COMANDO DA AERONÁUTICA
CENTRO DE INVESTIGAÇÃO E PREVENÇÃO DE
ACIDENTES AERONÁUTICOS

FINAL REPORT
IG - 057/CENIPA/2015

OCCURRENCE:	SERIOUS INCIDENT
AIRCRAFT:	PR-MHV
MODEL:	A320-214
DATE:	08APR2015

COMMENTS BY THE BEA

Regarding Section "1.7", page 11/12. Figure 4 and 5.

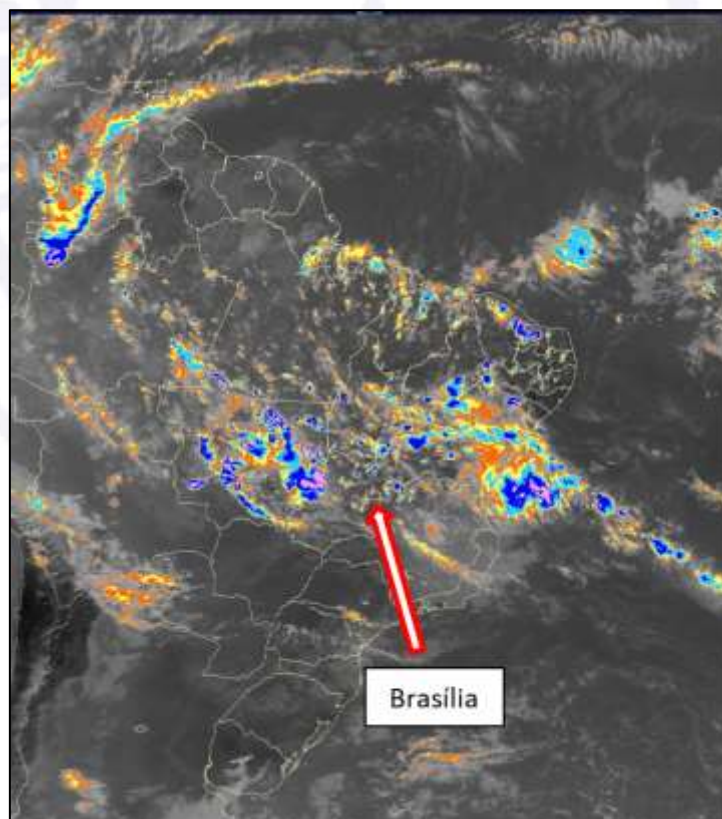
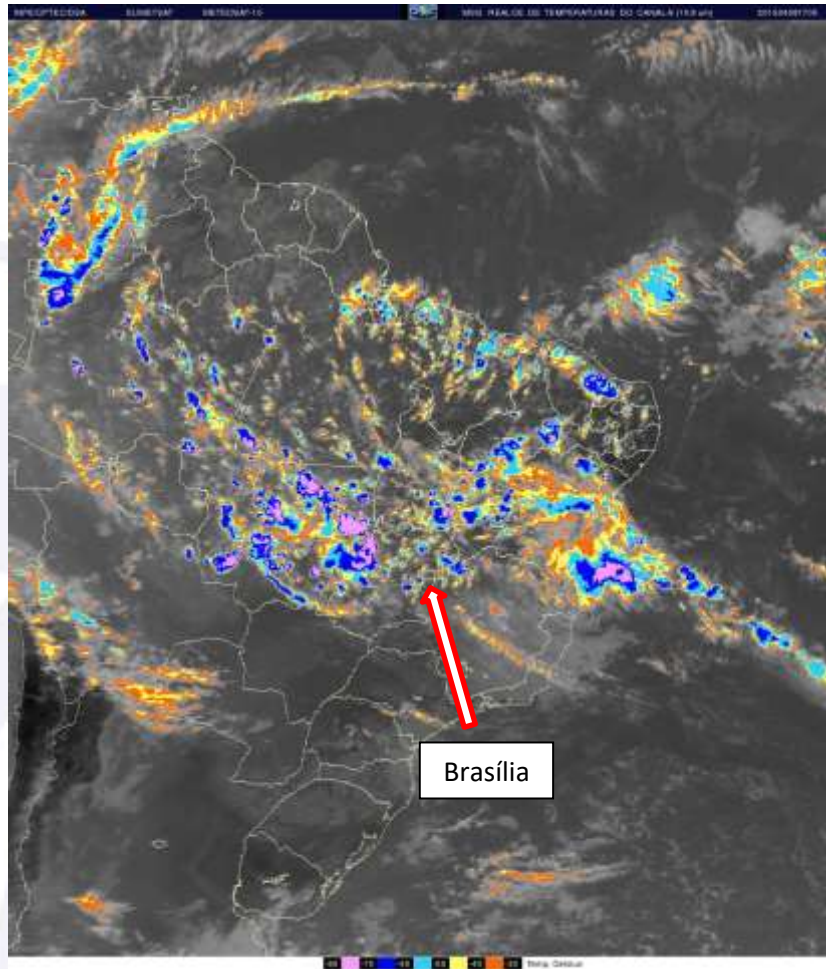
I suggest you add SBBR location on the weather satellite image.

The SBBR location was added.
